RE: 20-26 O’Connell St, and 33-35 Bligh St Sydney – Objection to proposed building comprising City East Zone Substation (Project application 2A(i))

I refer to the proposed building for the site at the above address, the subject of a Part 3A application for approval. Urbis has been commissioned by the Lowy Institute, owners of the adjacent heritage listed building at 31 Bligh St, to prepare this objection to the proposal.

Figure 2 – Bligh Street Elevations

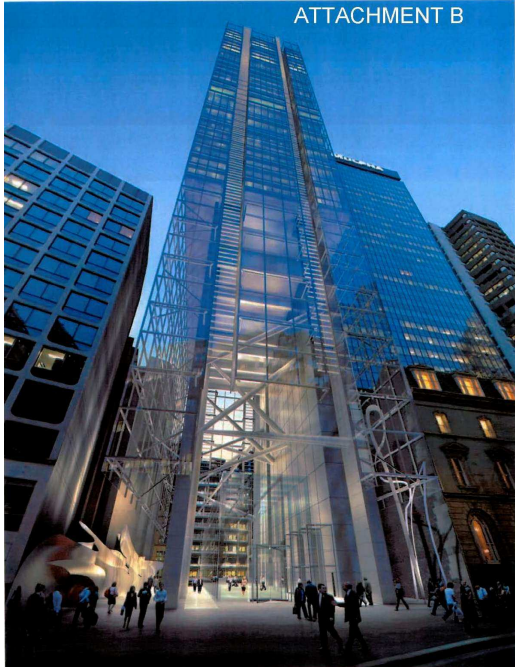
1.4.1 *The projection of the footprint of the proposed building is further forward of the previously negotiated outcome for the building line on Bligh St;*

In 2008 a scheme comprising a high rise commercial building by Rice Daubney architects was approved by the CSPC. The scheme provided for a setback to Bligh St to allow the new building to fall into the building line set by 31 Bligh St and 37 Bligh St. It also provided for an iconic building with a transparent and generous thru-site link, which would have formed an highly resolved architectural backdrop to Richard Johnson Square, with public art and high visibility which complemented the public square.

In contrast, the (concept) scheme put forward as part of this application provides for a design based on the requirement to provide a number of electricity transformers and basement service access. Along Bligh St, the requirement for transformer space has resulted in the proposed building being located against the site boundary, which results in the proposed building sitting forward into Richard Johnson Square, as is the case of the existing building. This situation is not satisfactory as the previously negotiated scheme provided a setback which should now be considered the minimum requirement for reducing the impact of any high rise proposal on Richard Johnson Square and the Lowy Institute Building at 31 Bligh St.

The views to and from Hunter St, as described on pages 1 and 31 of the Design Report, illustrates the overpowering impact of the proposed bulk and solidity of the proposed building on the view to Richard Johnson Square from Hunter St, and the impact on views to 31 Bligh St from Richard Johnson Square and Hunter St. While the existing building follows the same boundary line as proposed, it comprises a tall colonnade at ground level which provides transparency that assists in minimising the impact on Richard Johnson Square and 31 Bligh St.
